I am writing to **object** to the Bowmans Creek windfarm as proposed by Epuron (the Proponent). It can be shown that Epuron **have not** met the requirements to address the principles of Ecologically Sustainable Development, **it has not been** assessed in accordance with the *Environmental Planning & Assessment Act 1979*, or as required by the Secretary's Environmental Assessment Requirements.

My areas of concern are outlined in my response to the Environmental Impact Statement (EIS) and associated documents as submitted by the proponent.

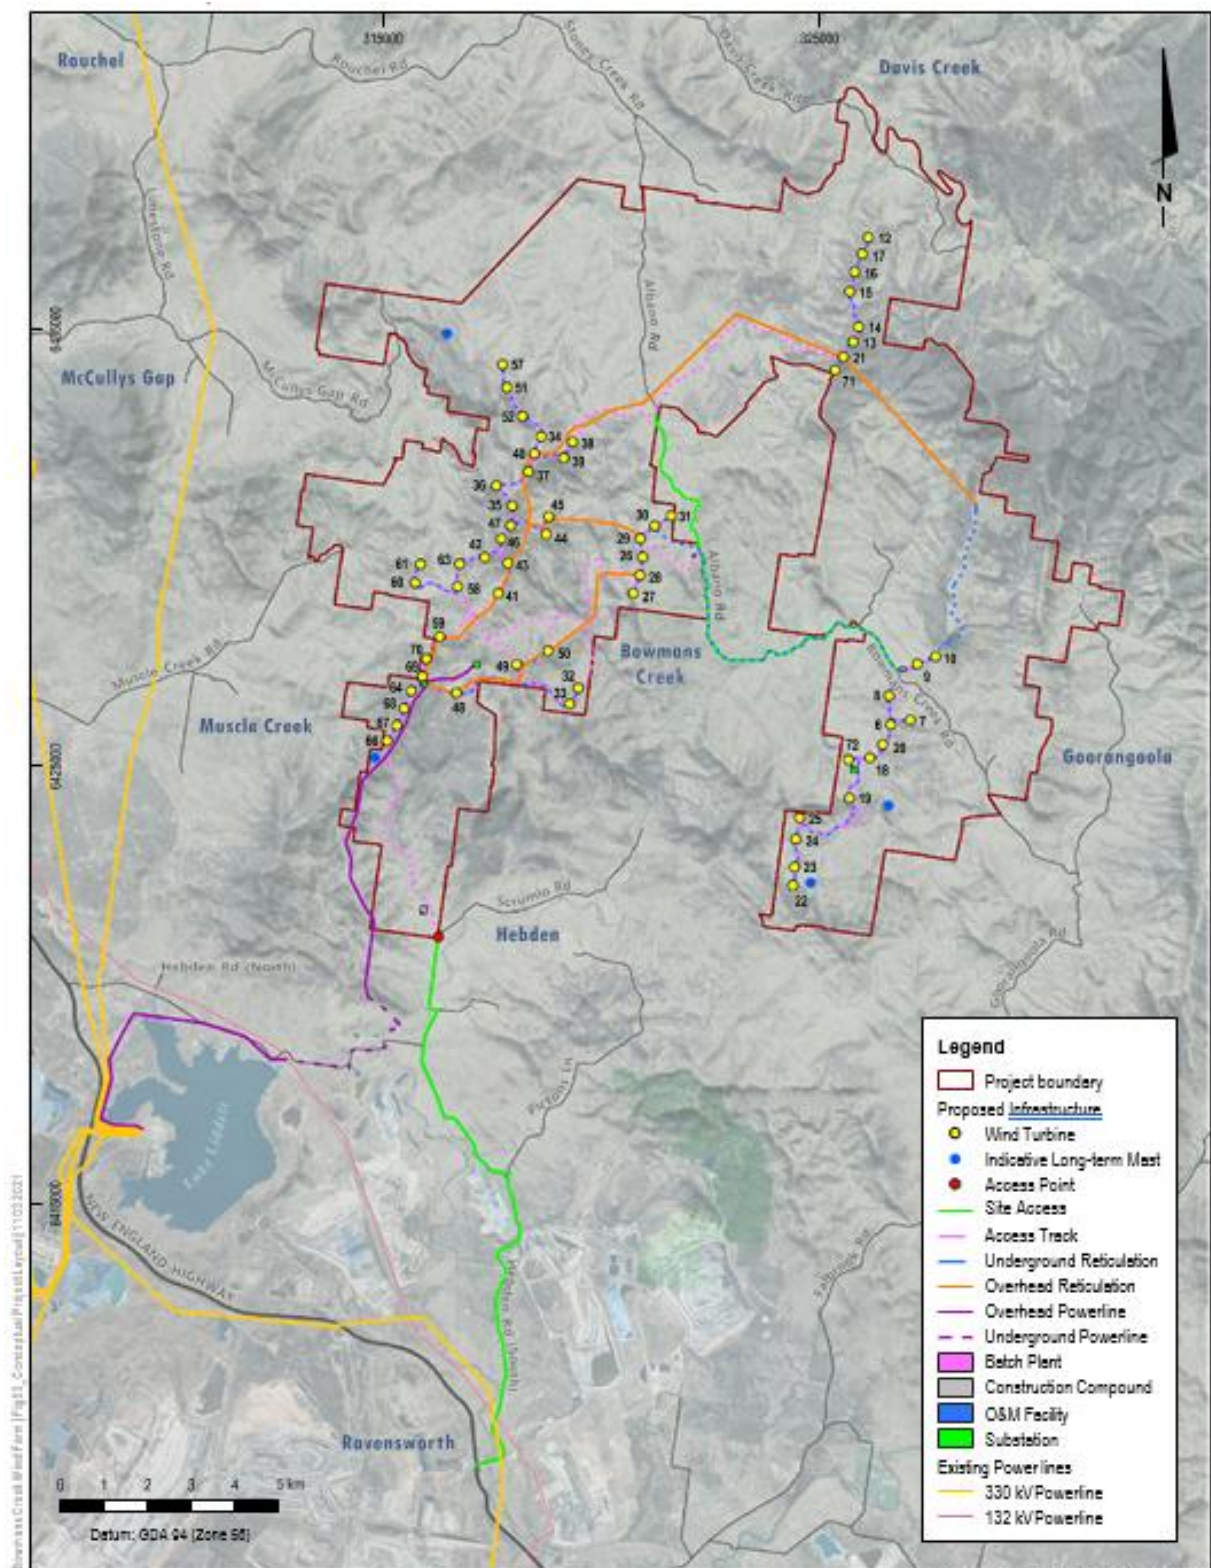
Figure 3 – Conceptual Project Layout (attached below) indicates where the four masts will be located. Figure 3 indicates one of the four masts will be located very close to our family home on a prominent ridge to the North East. I have not been consulted about this development and I am aware my neighbours who are not associated with the project have not been consulted about the development.

The EIS is clearly trying to ignore the construction of these four permanent masts, there are no access tracks into the mast indicated on any of the plans included in the EIS, the area of disturbance has not been calculated, and the design parameters are very limited. The only reference to the design parameters is included in **Appendix H Landscape and Visual**.

Section 3.4.2 Wind Turbine Generator Locations Includes three plans Figure 16, Figure 17 (attached below) and

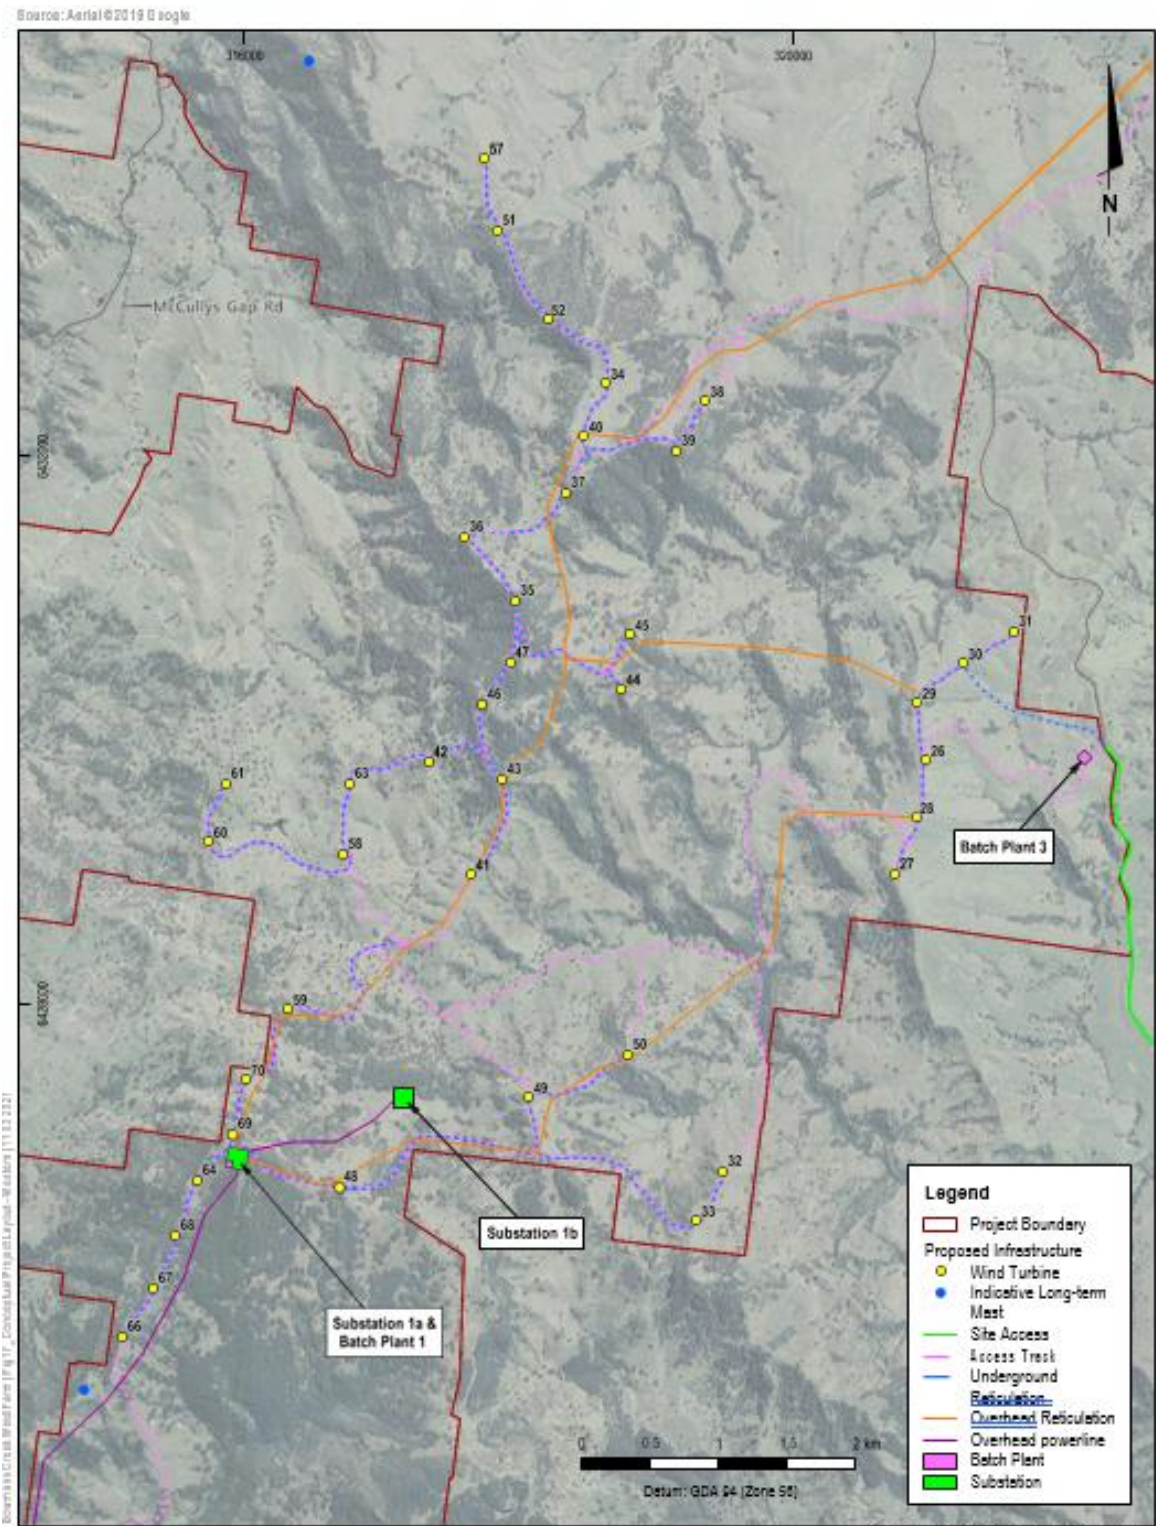
Figure 18 these three plans indicate the location of the site Access tracks. There are no access tracks indicated for any of the four Long term monitoring masts on figures 16, 17 or 18.

Dwelling H12-1

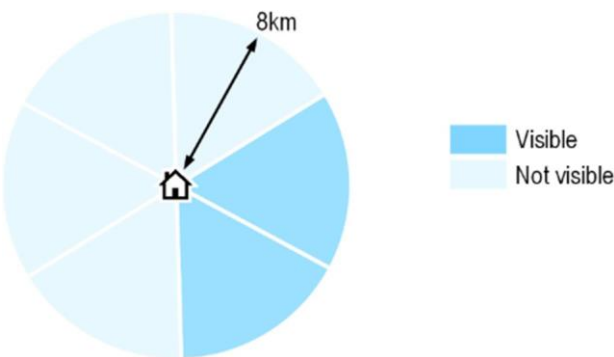
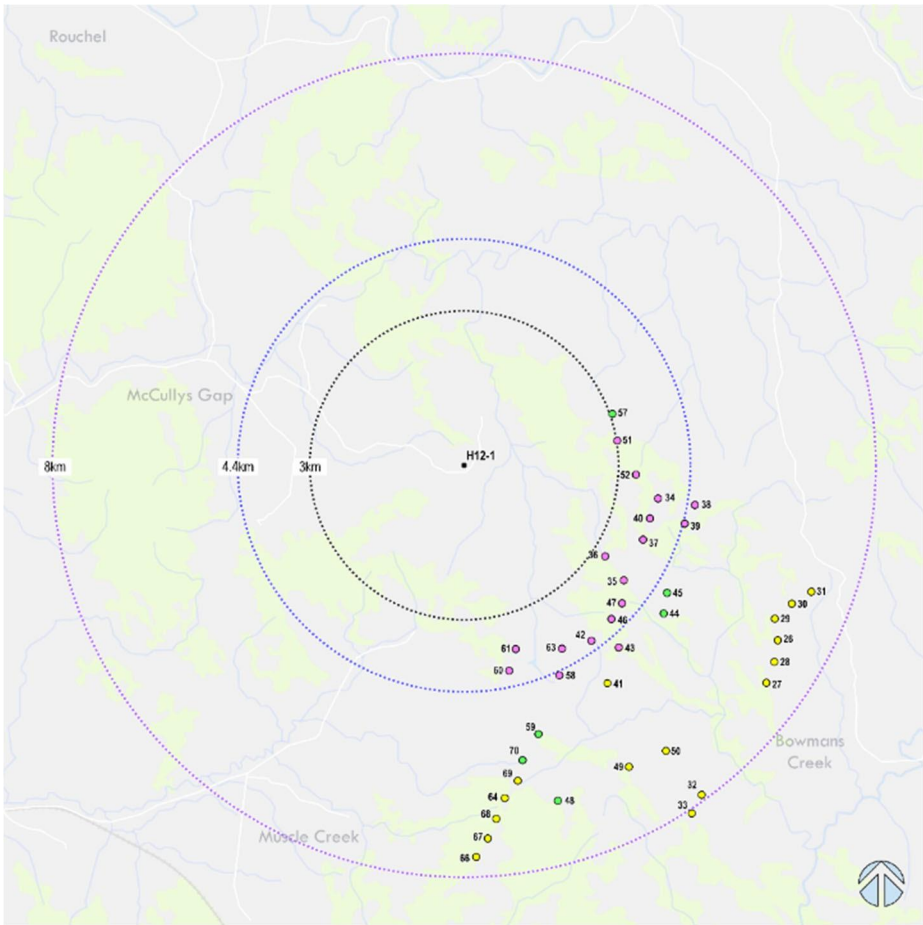
The permanent wind monitoring masts have not been used in evaluating and assessing the impact on my home.

Our home is identified as H12-1 and the assessment from **Appendix H is (attached below)**. Please note the table includes the following. **Ancillary electrical infrastructure including substations, internal electrical reticulation and 330kV transmission line will not be visible from the dwelling (our home).**

Figure 50 (attached below) indicatively shows the mapped bushfire prone land within the Project Boundary.

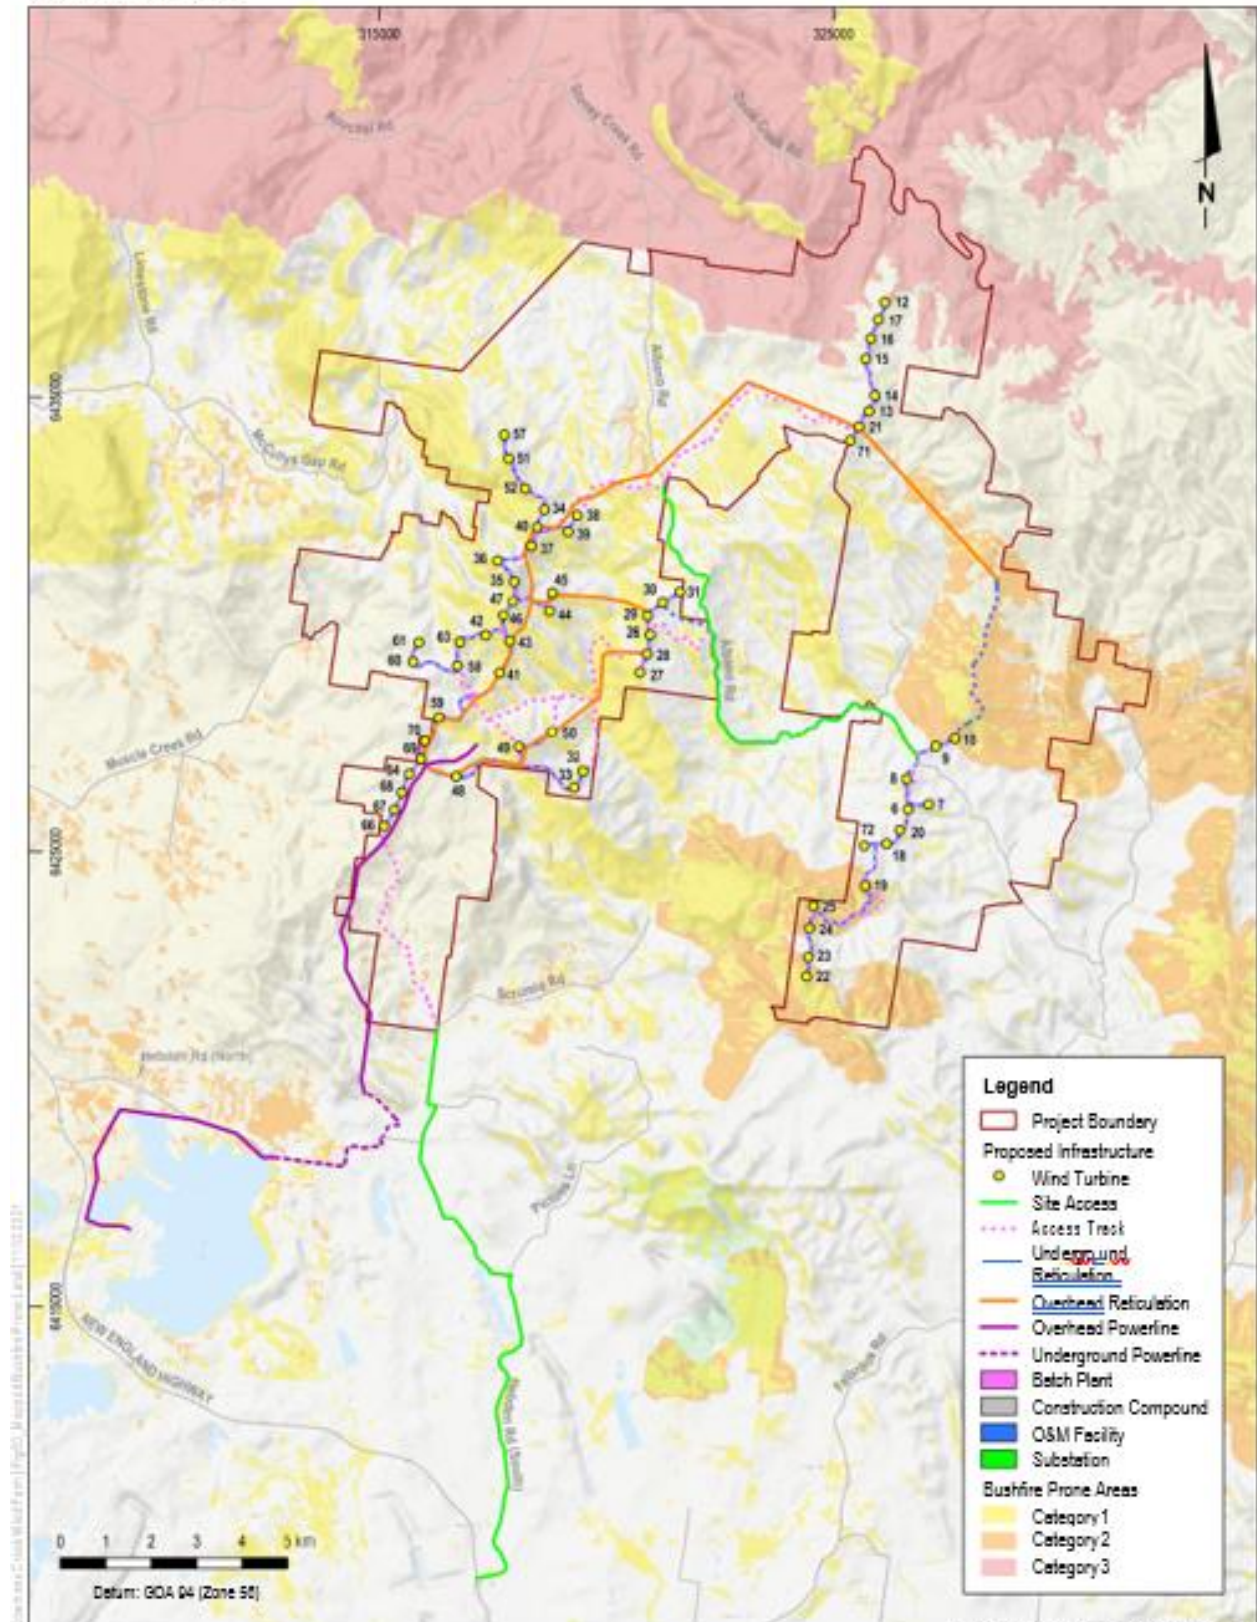
Figure 50 does not reflect the statements Epuron made **“The most prevalent vegetation category within the Project Boundary is Vegetation Category 1”**.

Figure 50 and commentary in the EIS is not supported by ground truthing or the reports available from the **RFS advice on their web site is the whole wind farm is built on Vegetation Category 1.**

Modified Figure 5 from the EIS Appendix H Visual Assessment

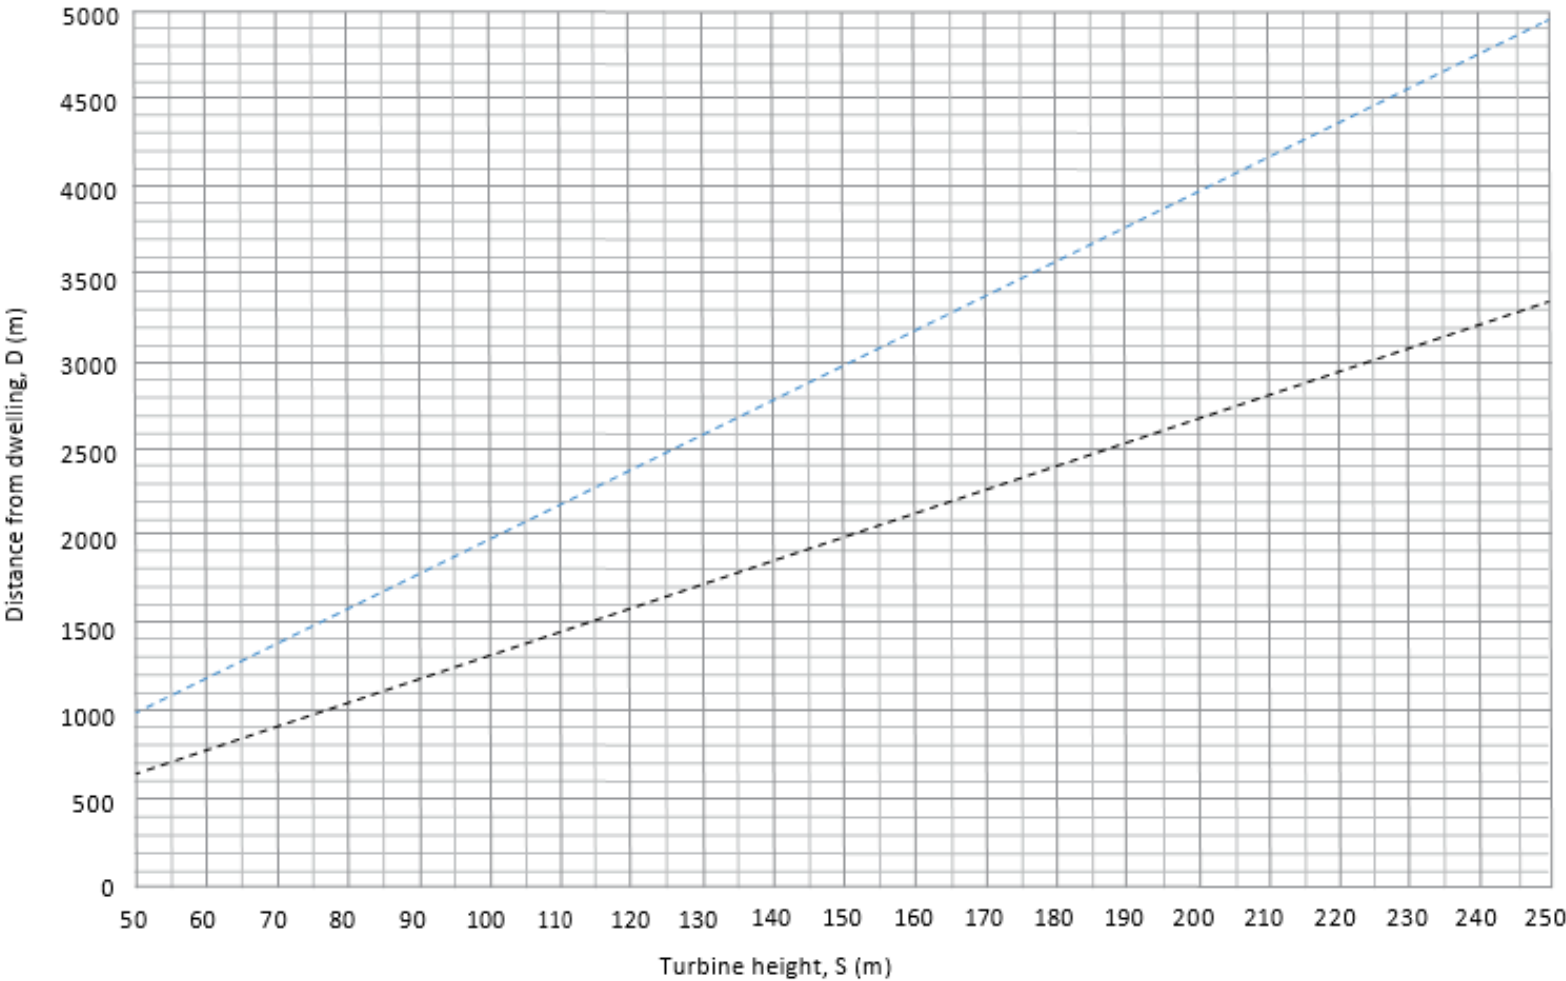
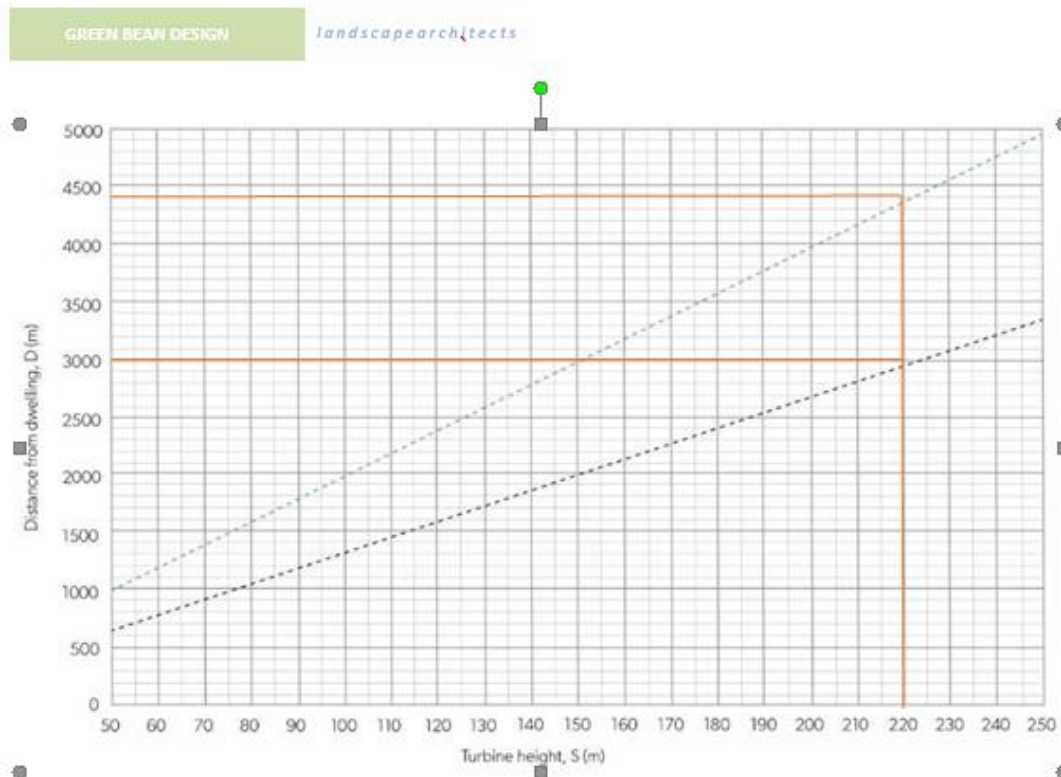
The EIS Appendix H Visual Assessment includes reference to Figure 5 from the Wind Energy Visual Assessment Bulletin. However, they have **modified Figure 5 (Modified Figure 5 attached)** Reference section 9.2 of the EIS appendix H.

Modified Figure 5 includes extra lines (in orange) with two horizontal lines coming across from two distance parameters being 3km and 4.4km, these lines intersect with a vertical line from the parameter wind turbine height 220m.

And whilst modified Figure 5 may be accurate for any properties that have the wind turbines located at a relative height of 220m (both the homes and wind turbines being built on the same m AHD Hight). It is not accurate for the majority of homes impacted by the wind turbines with the relative height of the wind turbines being well in excess of 220m. This can be demonstrated in reference to the two table I have included in this response document. The tables being:
